HERITAGE REPORT (2015-0202-HR01)

DA Application Reference: DEV2020/1134/18
Staged Development at 39 Abbotsford Road,
Bowen Hills - Lot 1 on SP287744

Work to a local heritage place - 'Abbotsford'

HERITAGE SUPPORT TO PROPOSED CHANGES AS PART OF A MINOR CHANGE APPLICATION

Proposed colour scheme for painted surfaces.
(Extract from the drawings.) (DKO Architecture)

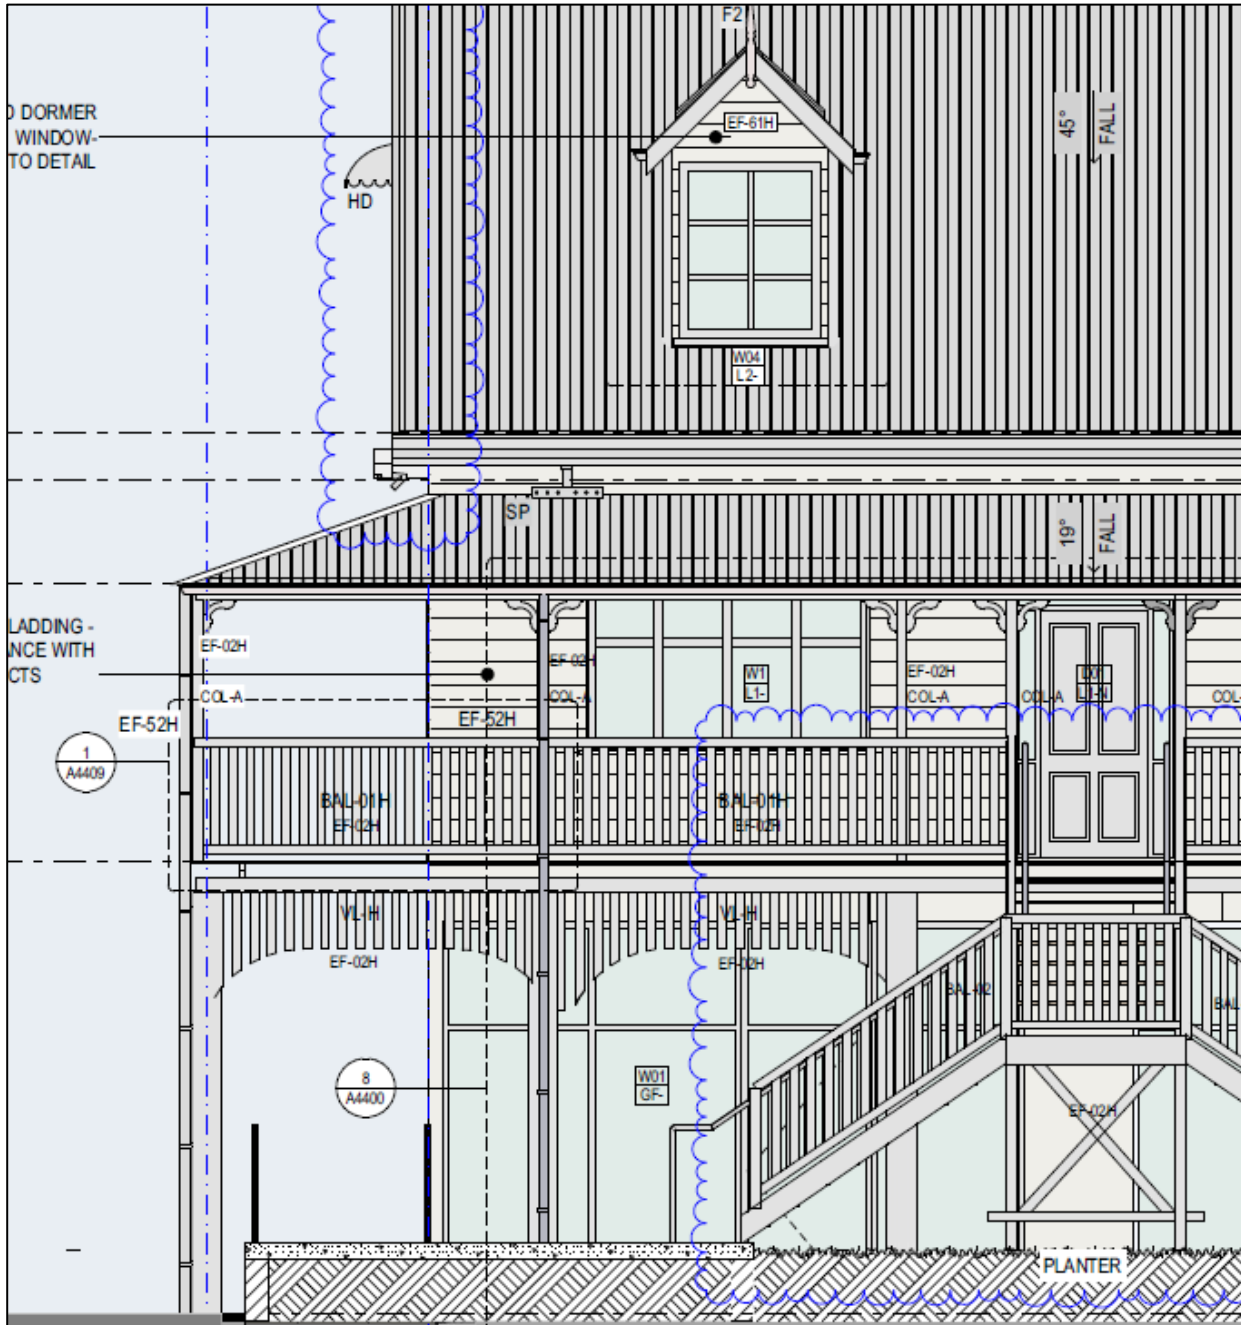
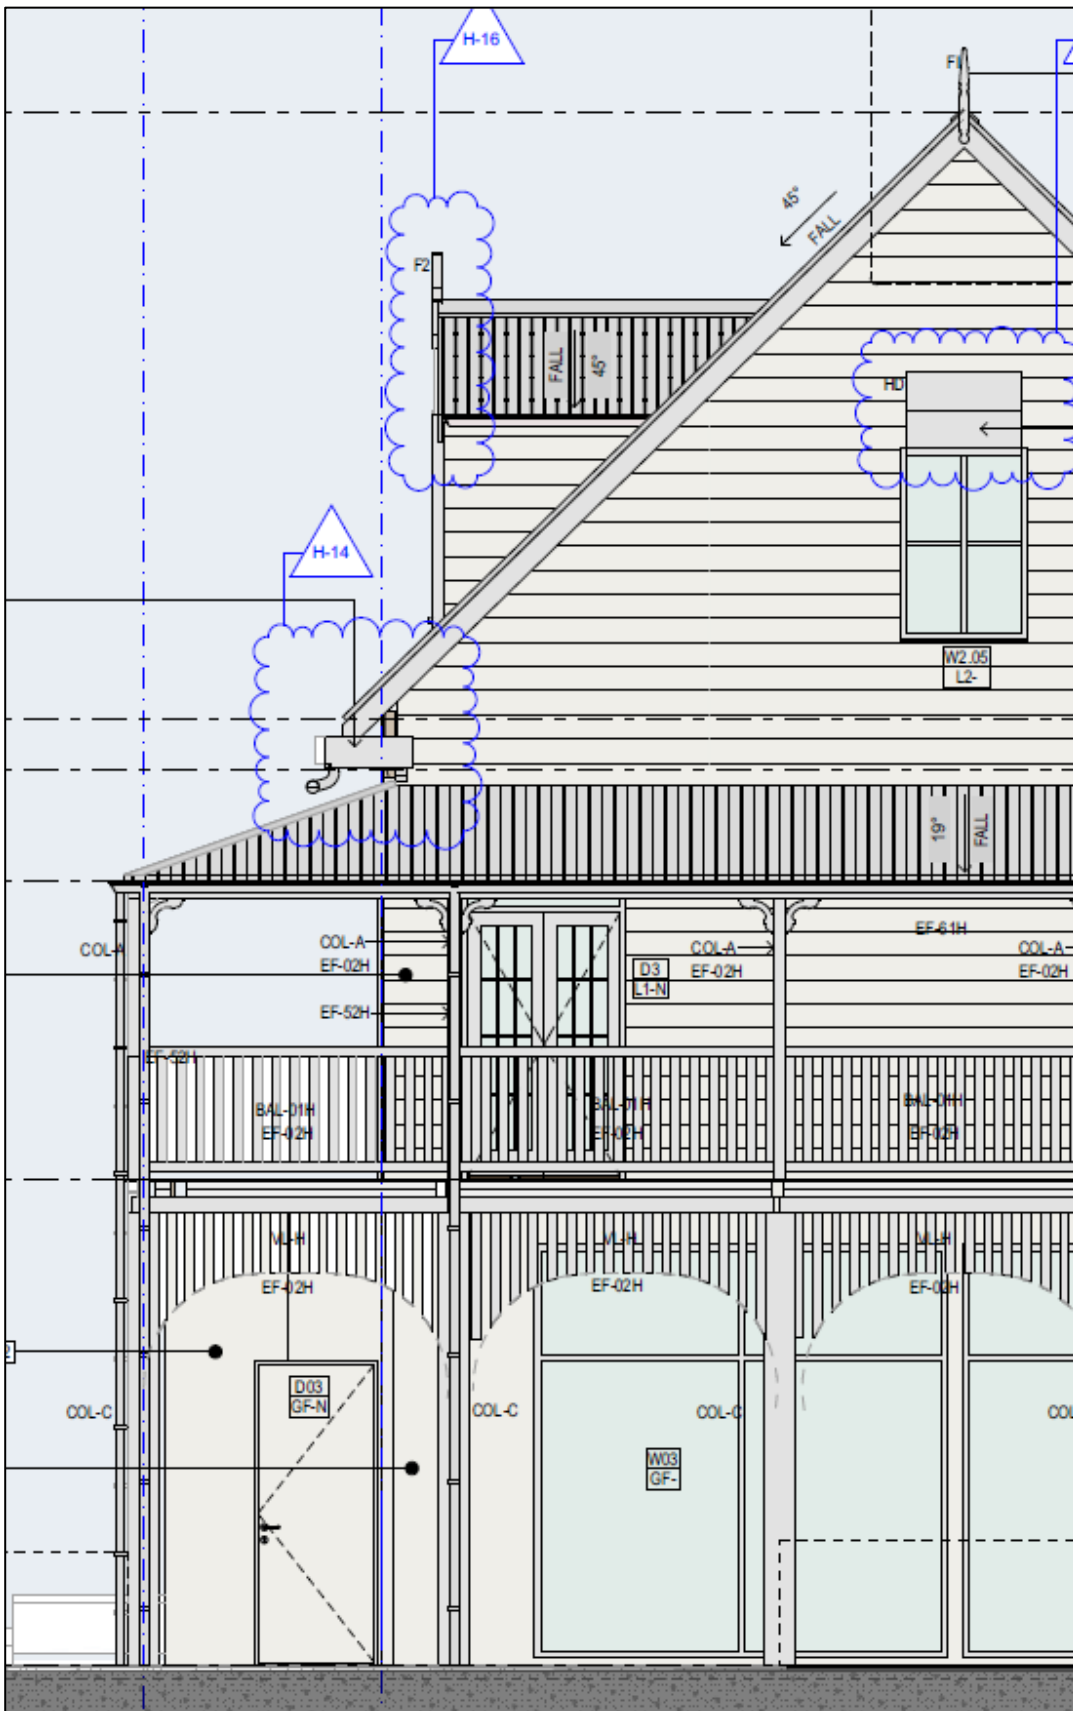
It is proposed to change the approved colour scheme to a colour scheme using predominantly lighter colours with some highlights in contrasting colours.

ENDORSED (19/5/2021) DRWGS	PROPOSED CHANGES (PURPLE MARK UP)	REVIEW ADVICE
Exterior colour scheme		
EXTERNAL ELEVATION NOTES FINISHES BY AREA U.N.D. RPT-01 (DULUX GOLDEN YELLOW 50154) RPT-02 (DULUX CHOCOLATE 50120) RPT-03 (DULUX LINE WHITE 57131) RPT-04 (DULUX BLACK 55669)  • EDQ notation states documentation is 'inadequate' • Gloss level should be noted as low-sheen (for acrylic) and satin (for enamel) • Where used on timber stumps, 'Dulux Black' should be noted as matt black.	Annotation from DKO stating: "CLIENT REQUEST TO REVIEW COLOUR SCHEME TO A LIGHTER OPTION". 'Change Request' memorandum (David Carter) notes: <i>"Lighter scheme preferred – more in keeping aesthetically with the overall development."</i>	Condition 15a of the development approval [DEV2020/1134] (under 'Compliance assessment – Colour Scheme') requires the applicant to <i>"submit, to EDQ DA, for compliance assessment details of the colour scheme for the Heritage Place (Abbotsford)"</i> prior to commencing building work on the heritage place. The applicant noted that they have a preference for an entirely white paint scheme as indicated at: https://www.binah.com.au/projects/the-abbotsford-bowen-hills. We note that this colour scheme does not appear to be informed by paint analysis, historic research or Heritage Architect advice. We also note that the City of Brisbane has produced detailed guidance on this matter –

The proposed colour scheme for painted surfaces uses some traditional colours together with other colours, applying them in a way which harmonises with the aesthetic of the overall development.

'Abbotsford' is included in the Local Heritage Place Sub-category of the Heritage Overlay of Brisbane City Council City Plan 2014 Planning Scheme. Colour schemes for painted surfaces (which excludes the natural finish of materials, such as galvanised roof sheeting) for local heritage places are not controlled by Brisbane City Council. Owners of local heritage places are free to use paint colours of their choice, the principle being that these do not materially affect the fabric upon which they are applied and can be easily changed.

The colour schemes for painted surfaces included in the BCC guideline documents are for the guidance of owners who want to replicate authenticity. Heritage places of State significance are required to use the original colour scheme based on evidence (such as by analysis/scrapings), if it exists, or by using traditional colour schemes, such as the ones in the BCC guidelines. The use of any other colour scheme is not prohibited – it just requires a level of assessment to ensure that the proposed colour scheme does not detrimentally affect the appearance and appreciation of the heritage place.

While it is understood that EDQ can apply conditions contrary to those applied by BCC in similar circumstances, it seems unreasonable to impose an unfair onus on the owners of this local heritage place, thus setting it apart from other local heritage places outside EDQ's control.

Consideration is to be given for approval.

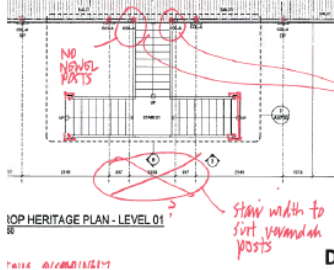
It is proposed to remove the proposed new annexe on the eastern side of the building and reinstate the original wrap around verandah.

ENDORSED (19/5/2021) DRWGS	PROPOSED CHANGES (PURPLE MARK UP)	REVIEW ADVICE
Annex under the verandah at east elevation ('Room 1.8') approved, to be accessible from a north-facing door to the verandah.	Annex proposed to be deleted and replaced with continuous verandah. 'Change Request' memorandum (David Carter) notes:	This change represents a less invasive alteration/addition and clarifies the extent/intent of the reconstructed wraparound verandah. It is considered a positive change and is acceptable.
	<i>"Rear annexe omitted – verandah to be reinstated."</i>

The proposed annexe was required to service the rooms on the first floor. A reconfiguration of the interior of the first floor as well as revising the PWD access requirements has meant that the annexe is no longer necessary. The toilets have been included in the reconfiguration of the floor plan. This enables the reinstatement of the full extent of the original wrap around verandah to the eastern side of the building, which is considered to be a very significant improvement.

As can be seen from the GJM Heritage 'Memorandum of Heritage Advice', this change was supported and consideration is to be given for approval.

Part of the first floor demolition drawing showing the extent of the new openings. (DKO Architecture)

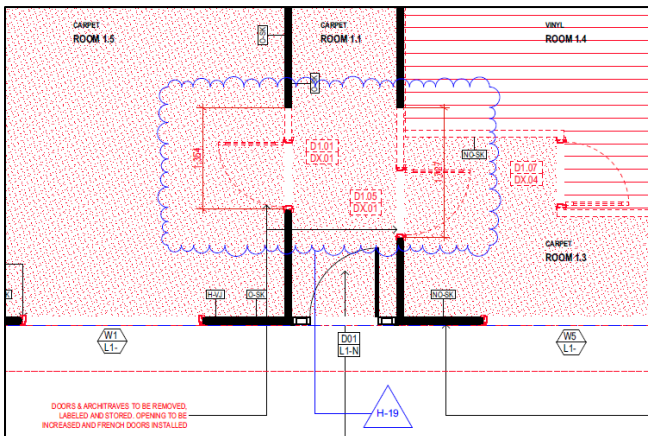
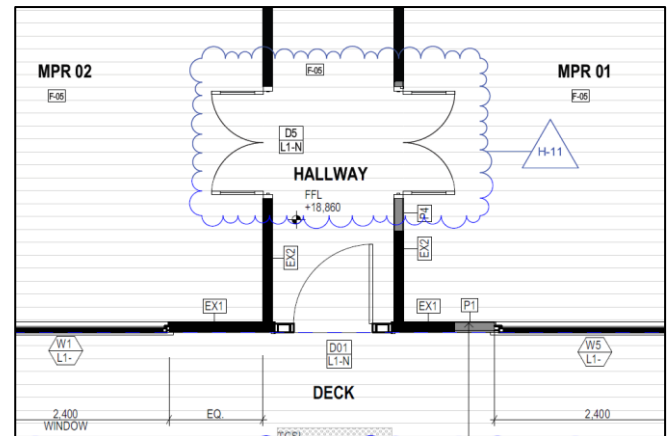
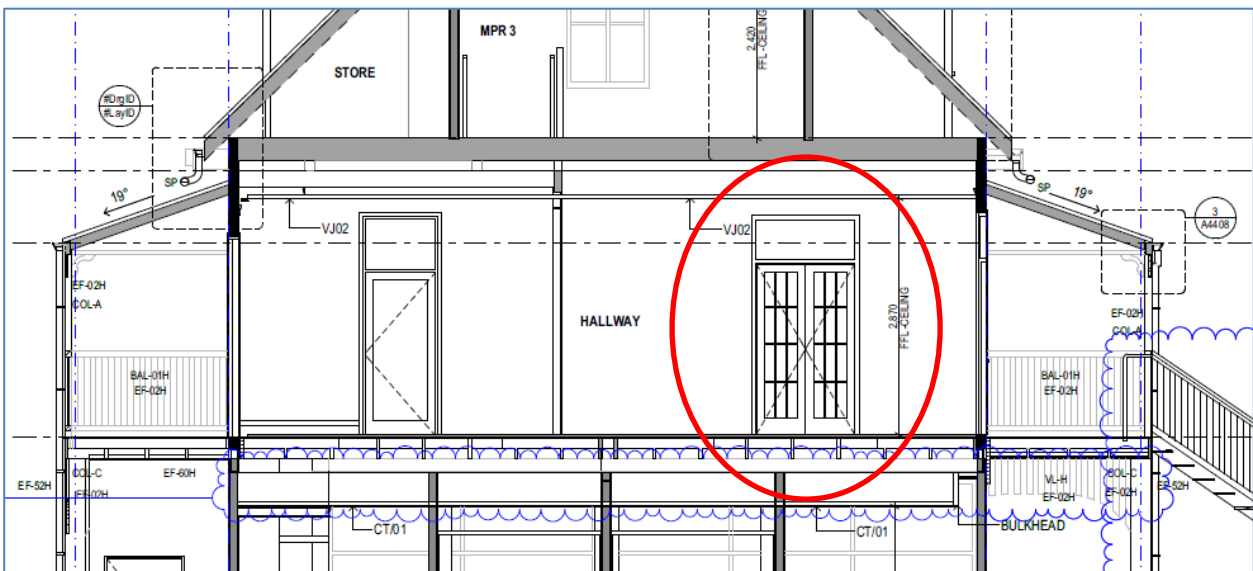
It is proposed to remove the door leaves, toplights, frames, architraves, etc from the two existing doorways at the western end of the hallway, increase the openings and install two pairs of contemporary French doors into the new openings. All original heritage fabric is to be identified and carefully stored on site.

ENDORSED (19/5/2021) DRWGS	PROPOSED CHANGES (PURPLE MARK UP)	REVIEW ADVICE
Two doors at western end of Room 1.1 (hall) approved for demolition and replacement on a like-for-like basis, retaining original fretwork to toplight and replicating extent details	These two doors are proposed to be removed and replaced with 'new French door' with toplight. DKO annotation reads: <i>"DOORS TO BE REMOVED & STORED / OPENING INCREASED, FRENCH DOORS INSTALLED."</i>	The proposed new uses for Rooms 1.5 and 1.3/1.4 are 'MPR' (Multipurpose Room). The Applicant indicated verbally that the intention is to allow these rooms to function as a single connected space across the hall if needed, and that French door suites were selected to differentiate the new doors from the historic doors. It is noted that no measurements for the
	 <i>Extract of section through hall looking north, showing French door.</i>	proposed expansion of the openings are provided. The expansion of original openings diminishes the legibility of the original building layout and is not supported unless clearly justified with an appropriate design response. This change represents a greater adverse impact on the heritage values of the place than the approved scheme. The replacement with like-for-like replicas of the early or original extent doors – as shown in the endorsed plans – is the preferred option.

While the two Multi Purpose Rooms will function independently, there will be occasions when both rooms are required to be used together. This increases the opportunity of using the combined rooms for larger functions, which the existing arrangement inhibits.

acceptable to remove some in order to achieve other requirements. In this case only two of the original four doorways are to be removed and the proposed arrangement preserves the legibility and spatial arrangement of the original plan form. The two remaining original doorways provide an understanding of the original heritage fabric and detailing.

The removed heritage components (door leaves, toplights, frames, architraves, etc) will be stored on site and can easily be refitted, thus meeting the heritage outcome of reversibility.

The revised arrangement is deemed to be an acceptable heritage outcome and consideration is to be given for approval.

View above the existing ceiling.

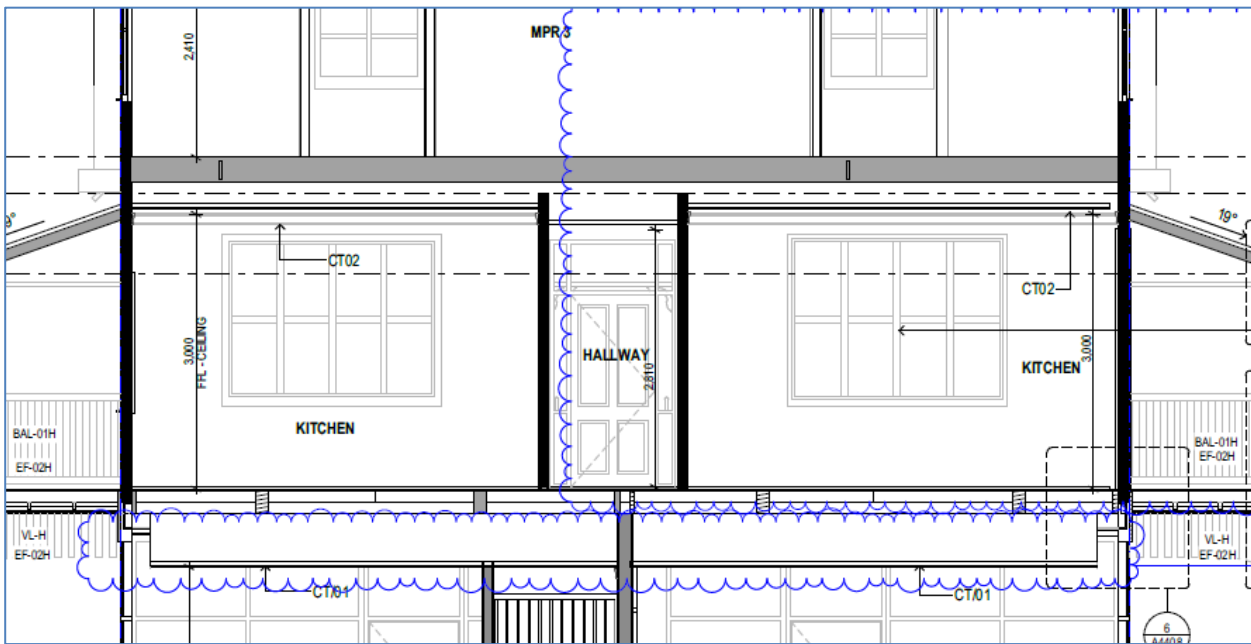
It is proposed to remove all the existing ceilings and cornices to the first floor and to install new vj boarded ceilings.

There is substantive evidence to suggest that the original ceilings were timber vj boards fixed to the underside of the floor joists of the floor above (see photos below).

It would appear that the extant fibrous (horsehair) plasterboard ceilings and cornices were installed when the building was altered which included the construction of the large dormers to the upper (second) floor. (See the BCC Heritage Citation for further information.). The substantially lowered extant ceilings were likely due to accommodating the plumbing and waste pipes for the wet areas above.

In the Multi Purpose Rooms (MPR 01 and 02 - Rooms 1.4 and 1.5) it is proposed to reinstate the beaded vj boards as the new ceilings which will also return these rooms to their original ceiling heights. These will be fixed slightly below the existing upper floor framing to allow for the introduction of additional structure to the floor framing due to its required structural upgrade. (Installing the new ceilings slightly below the existing floor framing will also allow the floor framing above to remain mostly untouched except for connections with the new structure and ceiling framing.)

There are justifiable heritage grounds for the existing ceilings to be removed and vj ceiling boards matching the original to be reinstated. Consideration is to be given for approval.
